SIB 64 02 25

## VIBRATION NOISE HEARD WITHIN INSTRUMENT PANEL

E-Series	Model Description	Affected Option Code
G26	i4 eDrive35, i4 eDrive40 Gran Coupe	With HA0 powertrain

Diagram - 64\_2792: Coolant lines - Graphic

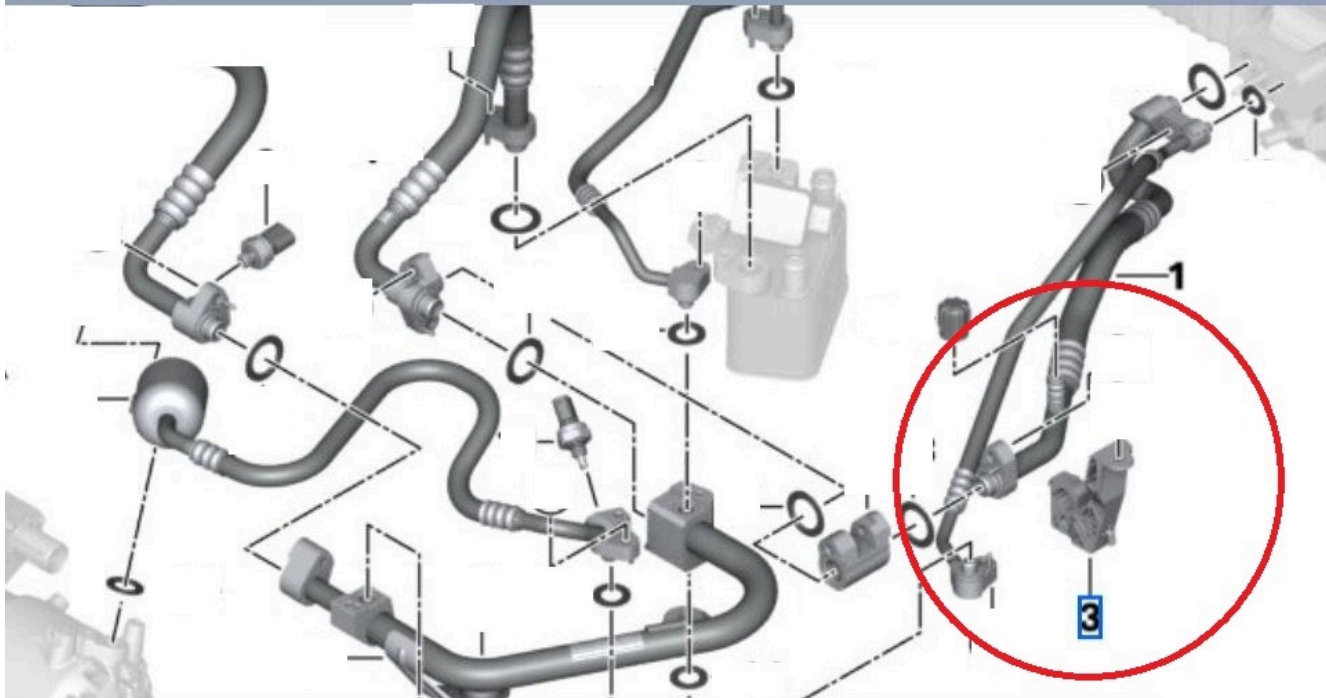
The customer states that when the AC system is on, there is a vibrating noise heard from within the instrument panel.

The noise is intermittent. The noise can be heard better outside the vehicle with the hood open.

Movement between the Air Conditioning Refrigerant line (dual line part number (P/N) 64 50 9 474 791, #1 in picture) and bracket (suction pipe air conditioner P/N 64 50 9 874 025, #3 in picture).

1- Ensure that the bracket suction pipe air conditioner P/N 64 50 9 874 025 is fully clipped into place as it goes around the dual wall AC line.

2-If there is still noise due to movement, unclip the AC bracket and wrap the dual-wall AC line with butyl tape where it contacts the bracket.

Then reinstall bracket around dual-wall AC line.
